**TOWN OF UNDERHILL, VT**  
Planning & Zoning Administrator

**MEMORANDUM**

To: DRB, SB, UJFD, UCC  
From: Sarah McShane, PZA  
Date: 12/1/2014  
Re: Agenda and Information for 12-1-2014 Hearing

**Hearing on the Application of Warren Palmer  
for a revision to the Isabel L. Baslow Subdivision (2009)**

**SITE PLAN**  
**WARREN PALMER**

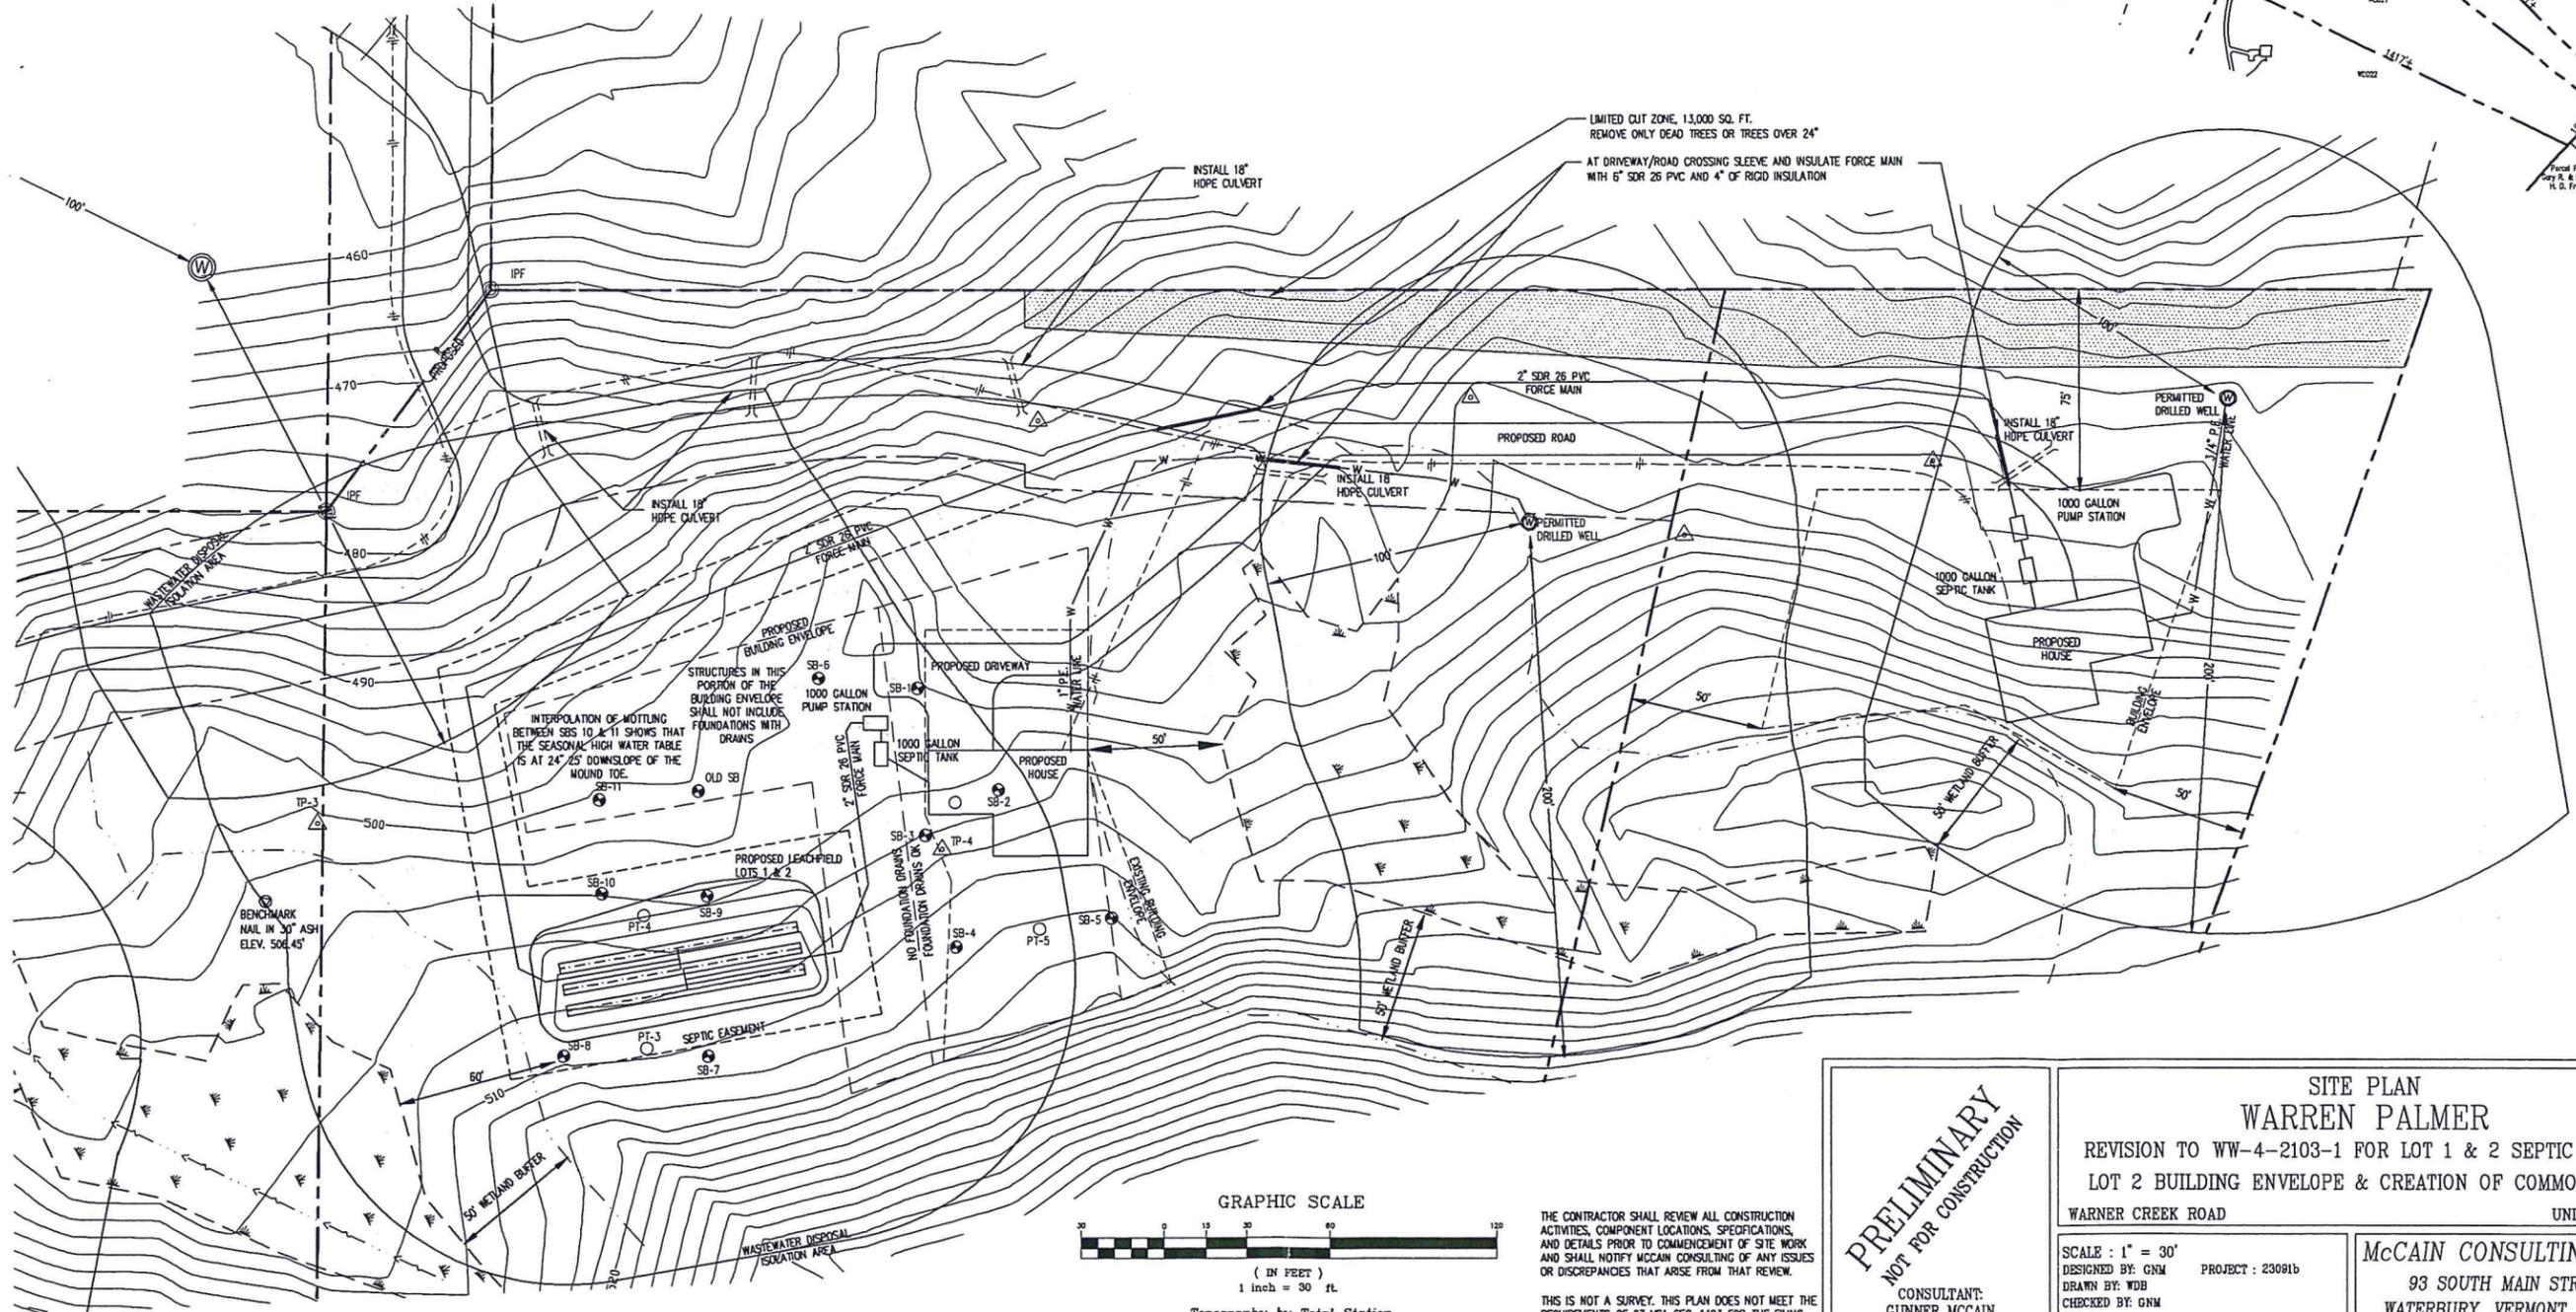
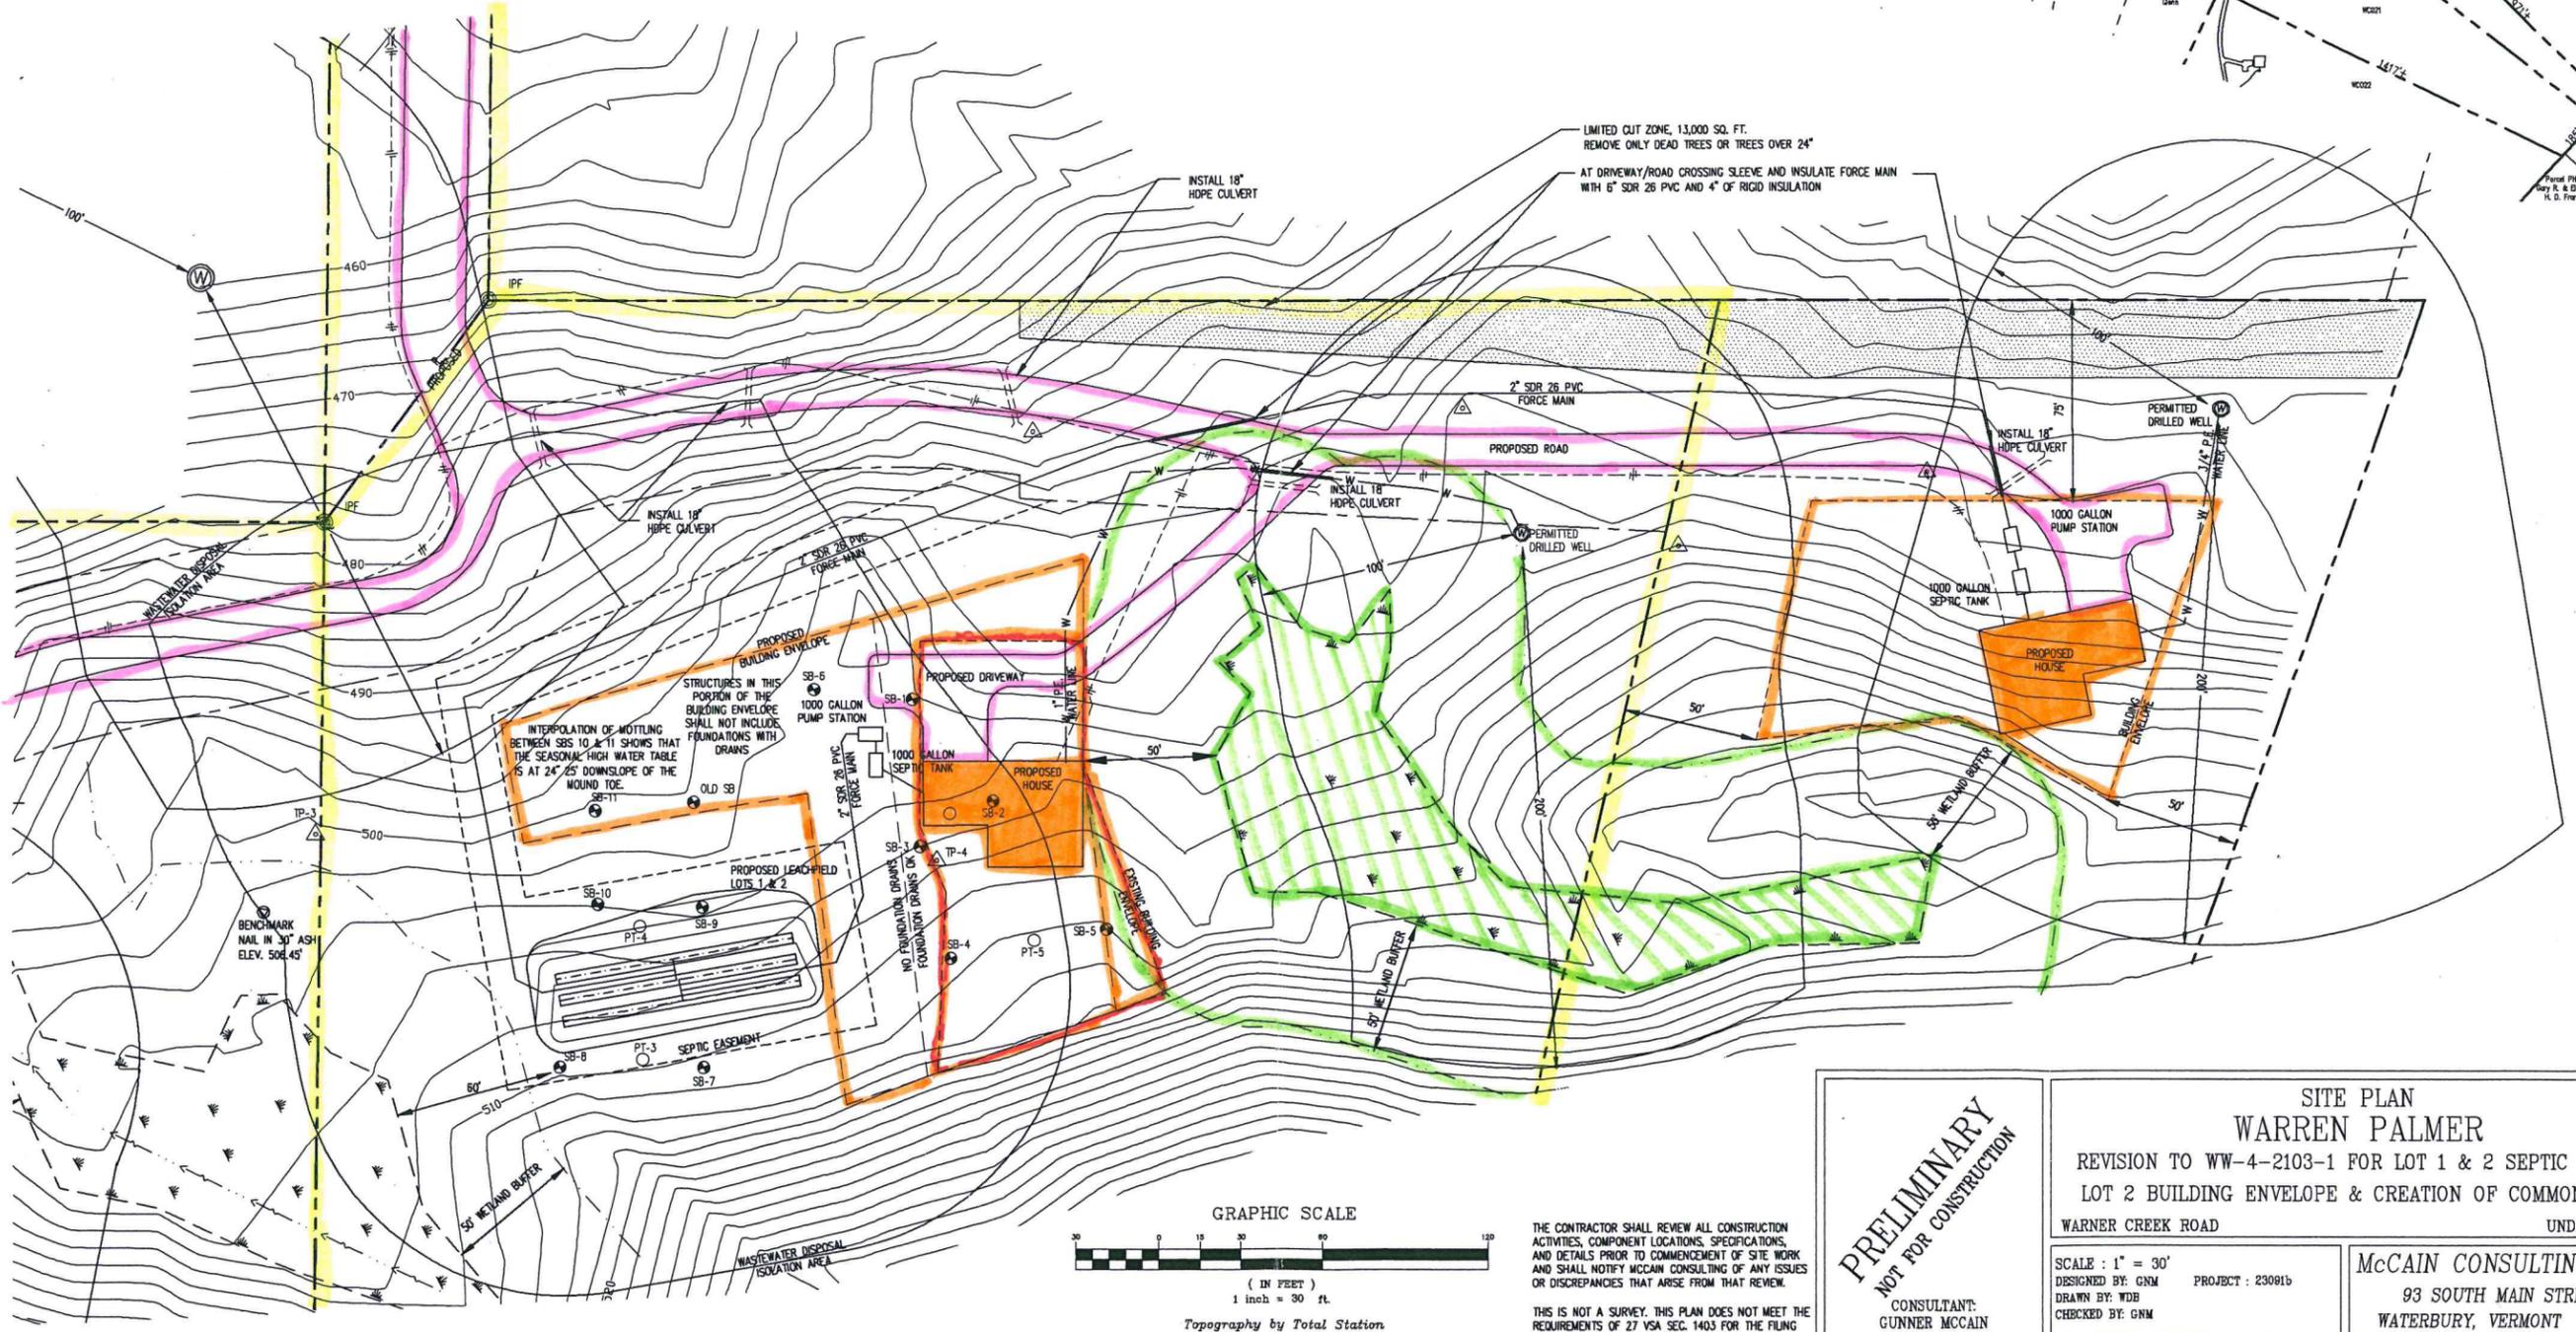
Portions of the area of Lot 2 appear to contain steep slopes (15%-25%) and very steep slopes (>25%) as indicated on the ANR Natural Resources Atlas. The application is for the re-subdivision of Lot 2 and to revise the location of the building envelope on Lot 2; there are no proposed changes to the road and driveway improvements. The proposed revised building envelope appears to avoid these steep areas.

The application and site plan indicate the presence of wetlands, but do not indicate the type of wetland (Class 1, 2, or 3) or when the wetlands were delineated. The wetlands do not appear on the State Wetlands Inventory. If they are Class 3, the buffer is incorrectly mapped on the provided site plan. Class 3 wetlands are only required to have a 25ft buffer.

Is there an existing wetlands permit for the project? If so, it should be amended to include the updated plans.

Per Section 3.19(D)(4), the septic system is located outside of the wetland buffer as indicated on the site plan.

The amended leach field is located outside of the revised building envelope. Do the current regulations require all site improvements to be located within the designated building envelope? See definition of building envelope on page 192; also see Section 8.2 (G) page 146.

The Subdivision Plan submitted is not a survey. The DRB should discuss if the amended building envelope and re-subdivision of Lot 2 should be recorded on a plat, and if so, whether the plat amendment should be prepared by a certified land surveyor. If so, does the DRB want to review the plat prior to final approval.
